Planning Applications Committee

Title	PLANNING APPLICATION REPORT
Ward	Abbey
Planning Application Reference:	PL/26/0415 – Application for Approval of Reserved Matters
Site Address:	Station Hill, Reading, RG1 1NF
Proposed Development	Reserved Matters application pursuant to Outline Planning Permission ref. 192032 for the development of Plots A, B and D at Station Hill, Reading, comprising the erection of two buildings to provide residential units (Use Class C3), including affordable housing, ground floor flexible commercial units (Use Class E), resident amenity space, associated landscaping and public realm works, including Station Hill Gardens and to Station Hill Square, new pedestrian routes, cycle parking, servicing, refuse storage, plant and ancillary infrastructure, with all associated works. Discharge of conditions which are triggered with the Reserved Matters Application including Conditions 54(iii), 63, 75, 76, 86, 94, 95, 96, 99, 107 and 112.

Applicant	SH Reading Master LLP
Report author	Steve Vigar
Deadline:	26 Week date: 25 September 2026
Recommendation	Delegate to the Director of Planning Transport and Public Protection to GRANT Reserved Matters Approval for the Access

Figure 5.2: Bin and Core Plan

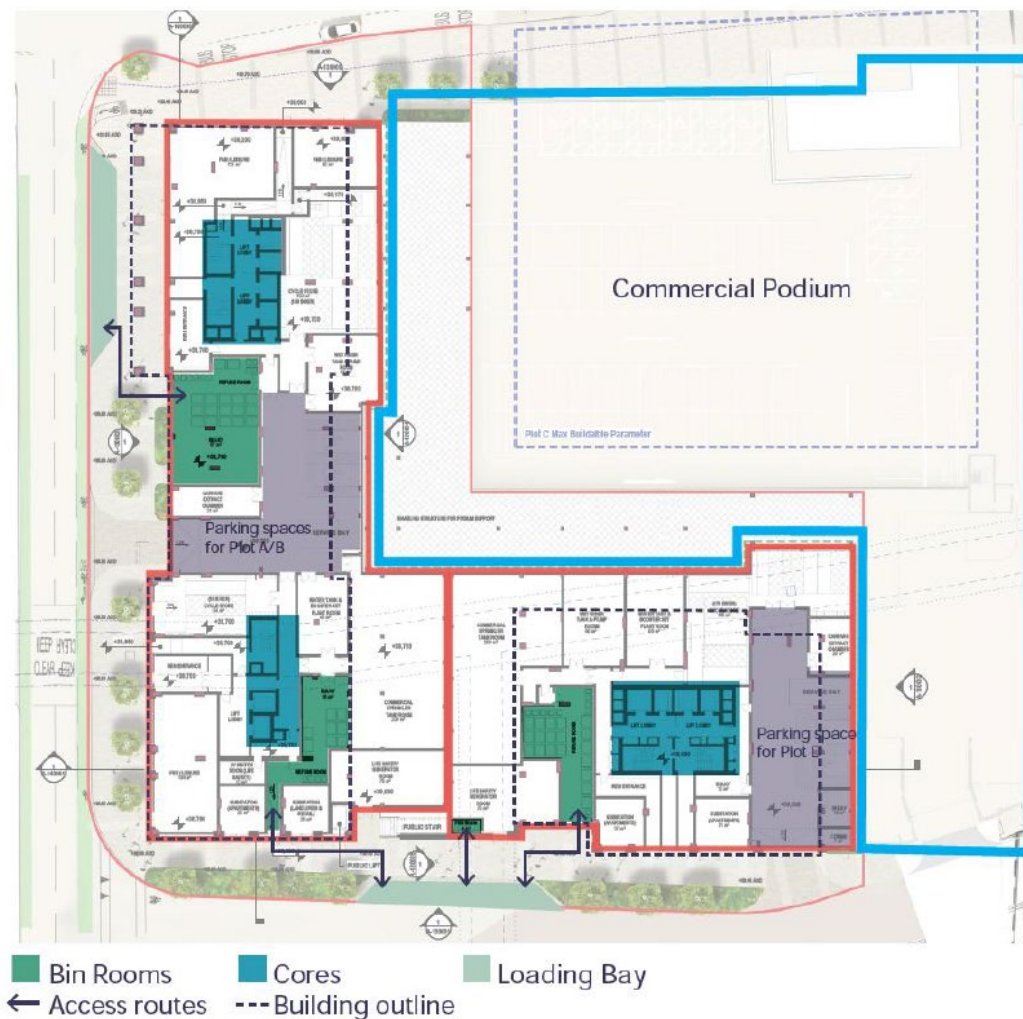
- 6.180 The S106 agreement secured under the Outline permission includes an obligation on the owner of the building
“Not to position commercial or residential waste bins within the public highway or Public Realm Areas and to ensure that the collection of commercial and residential waste is carried out from within the service areas of the Buildings.”
- 6.181 This is fundamental as it prevents waste from overspilling from the development into surrounding public areas and acts as a strong incentive on the owners and occupiers to manage the waste properly within the site.
- 6.182 As described in the decentralised energy section above, the space within the building is at a premium due to the additional requirements of the Building Safety Act and the requirements of the approved Design Codes and Parameter Plans to secure appropriate amounts of active frontage.

- 6.183 This results in the bin stores being necessarily deep in terms of their footprint (it would not be desirable for them to occupy more of a frontage than is strictly necessary) and also constrains their size to a degree which limits the amount of waste which can be stored at any one time. As to the case in the town centre this will not fit with the Council's standard collection arrangements and will necessitate a private collection. The submitted details confirm that the storage is designed around three collections per week for all waste and which reflects the approach already undertaken with the 598 flats constructed at Plots E and F ("Ebb" and "Flow") within the wider Station Hill site.

Image 1 – Diagram illustrating desire line

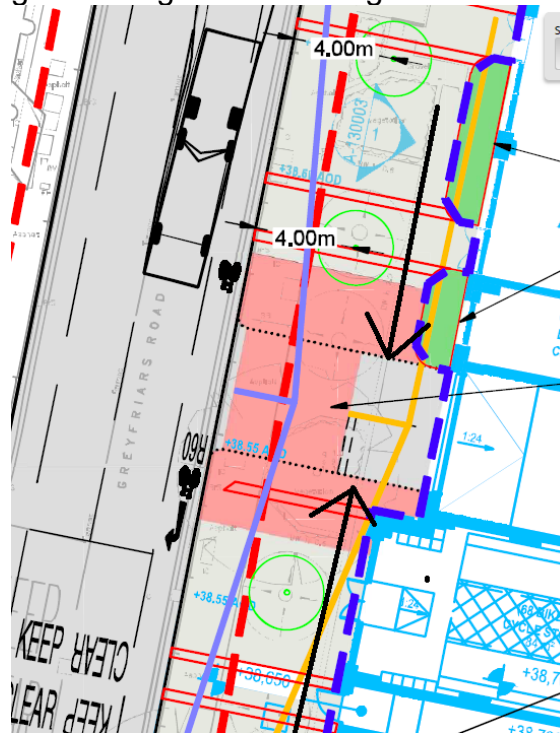
Visibility splays for the vehicle accesses have been illustrated and the Greyfriars Road splay is deemed acceptable. A cycle visibility splay has been illustrated at the access onto Greyfriars Road but the give way line has been positioned along the desire line for pedestrians and cyclists. The applicant has stated that the landscaping around the access onto Greyfriars Road pushes cyclists away from building edge and the raised table now provides a desire line for pedestrians away from the give way line. However, as Image 1 below illustrates by way of the black arrows there is still a desire line for

pedestrians and cyclists right adjacent to the building line especially as a cycle store and residential entrances are located directly south of the vehicle access.

As had been previously discussed and agreed at the pre-application meeting some form of increased physical measure is required to effectively direct pedestrians and cyclists away from the building edge to ensure that adequate sightlines are provided. It had been agreed that low level landscaping would be provided similar to what has been proposed to the north but a larger area on both sides of the access but this has not been illustrated on the submitted plans. A proposal similar to that provided at Image 2 below must be incorporated into the scheme design or the give way line would need to be set back into the site and the building line adjusted to facilitate the visibility splay.

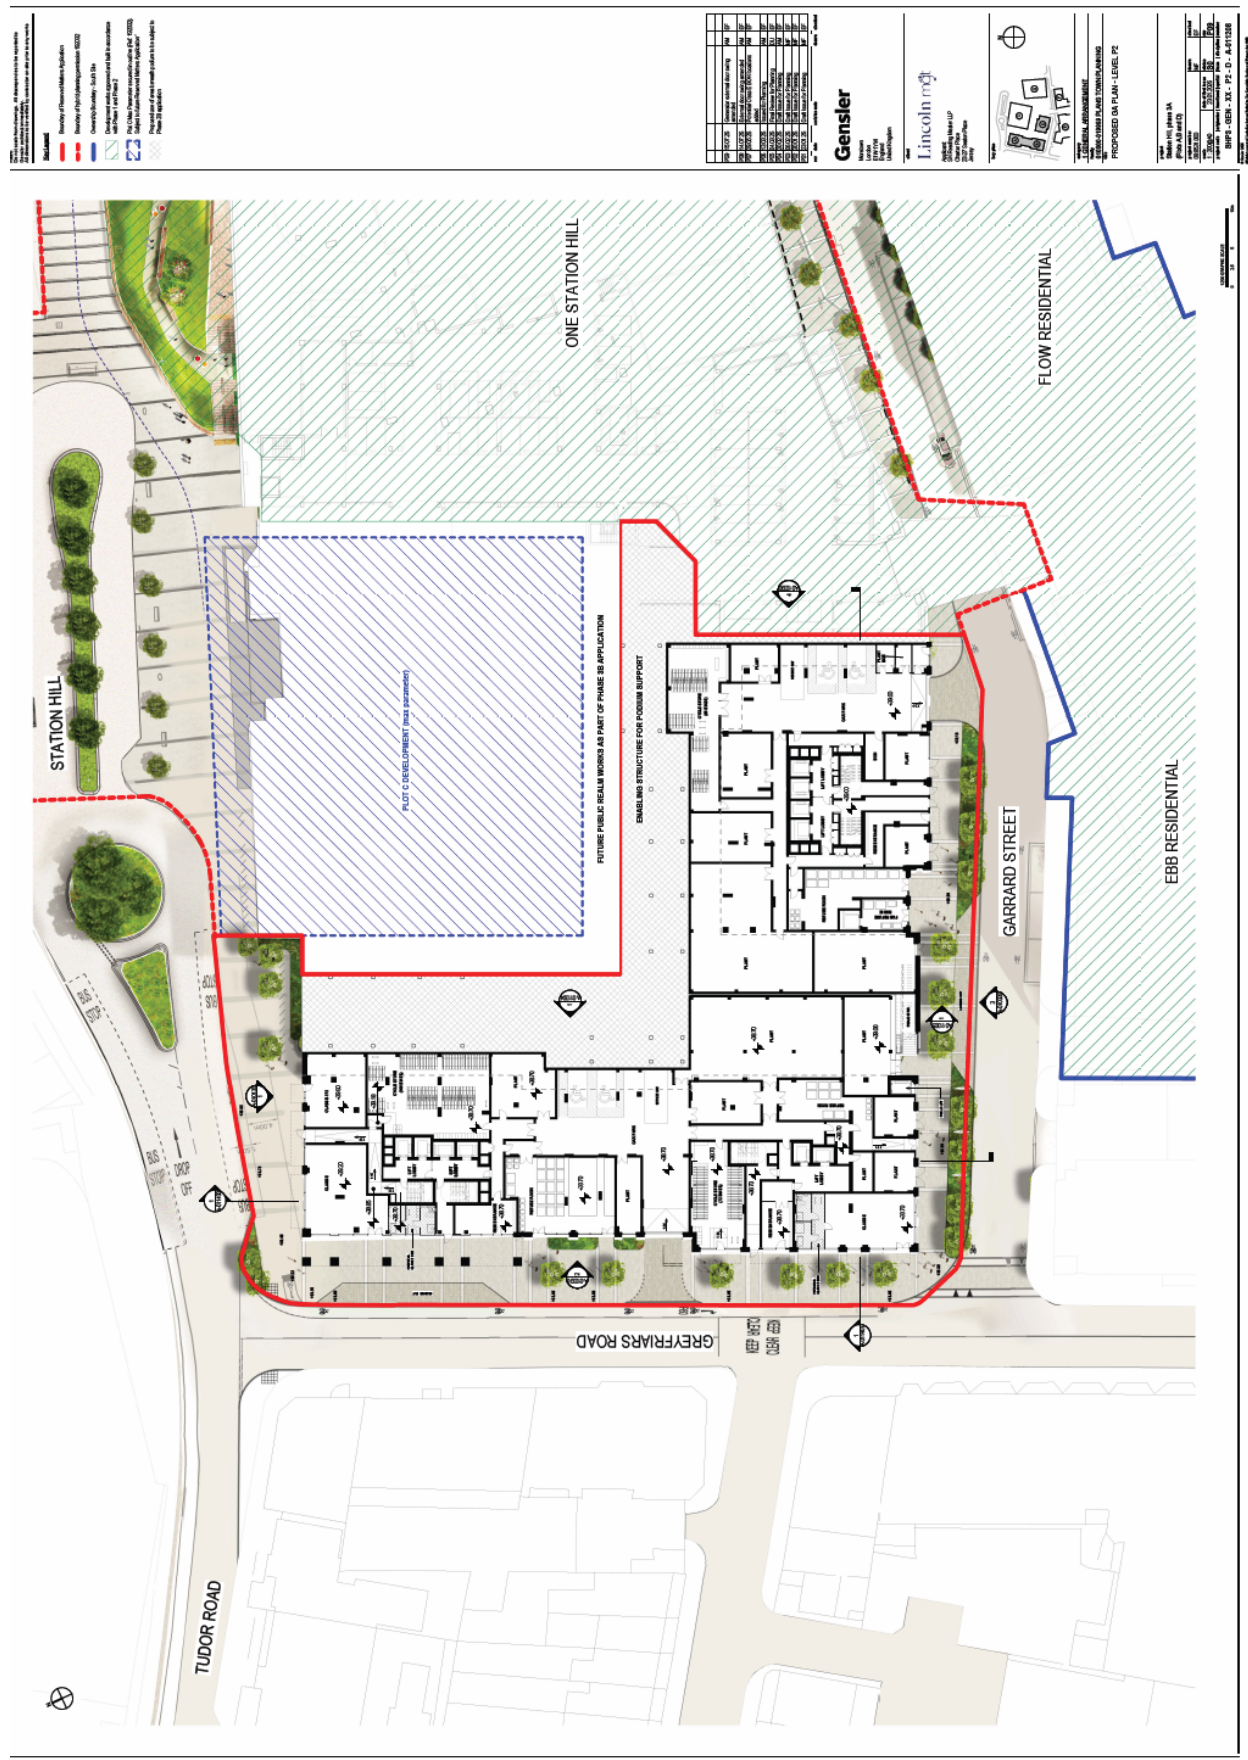
- 1.3. ATE recommends the applicant undertake the following:
 - Re-assess cycle parking requirements in accordance with the minimum suggested standards set out in **Local Transport Note (LTN) 1/20 (Cycle Infrastructure Design) Table 11.1**, with particular emphasis on the provision of spaces for non-standard cycles.

- Provide a convenient access to cycle parking within Building A of the proposed development, which would encourage everyday cycling.
